This notice is sent to you in accordance with the National Traffic and Motor Vehicle Safety Act. Waterous Company has decided that a safety related defect may exist in certain model C20 and C21 split-shaft transmissions and model TC20 and TC21 PTO split-shaft transmissions manufactured from April 9, 2015, to April 20, 2016. This condition could potentially result in the inability to shift the apparatus from road to pump mode.

You are receiving this letter because our manufacturing records indicate the following Chassis VIN number/numbers are affected by the National Traffic and Motor Vehicle Safety Act recall # 16E059.

Clevis Pin Retrofit Kit Instructions NHTSA Recall 16E059

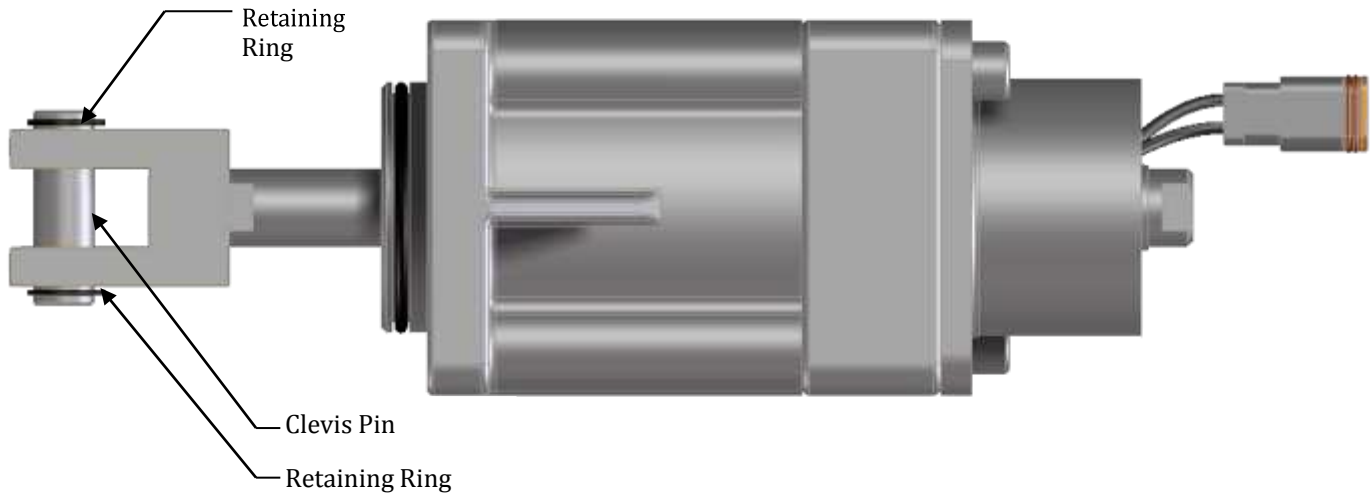
7. Record the shift unit date code stamped into the back of the shift unit as shown below and enter into Certificate of Remedy and Disposal.

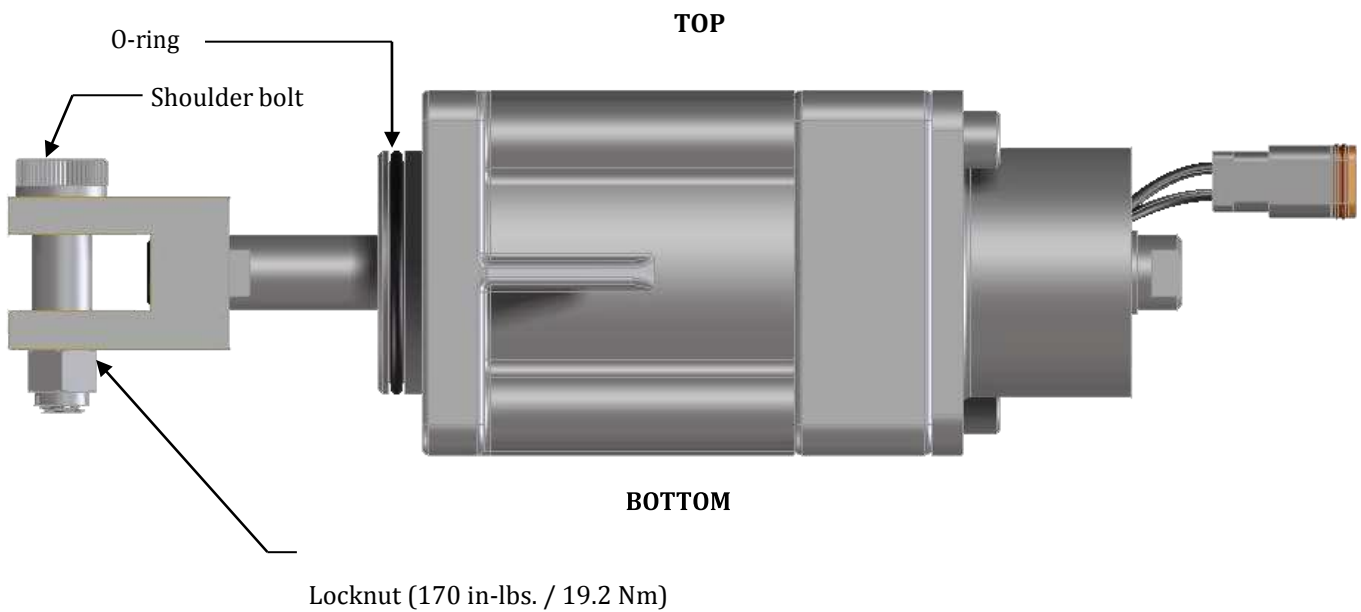
8. Remove one retaining ring from the clevis pin and remove pin as shown below.

9. Remove and replace shift unit O-ring, coating O-ring with grease upon replacement.
10. Install shoulder bolt and locknut as shown below. Head of shoulder bolt must be on top. Torque to 170 inch-lbs. / 19.2 Nm.
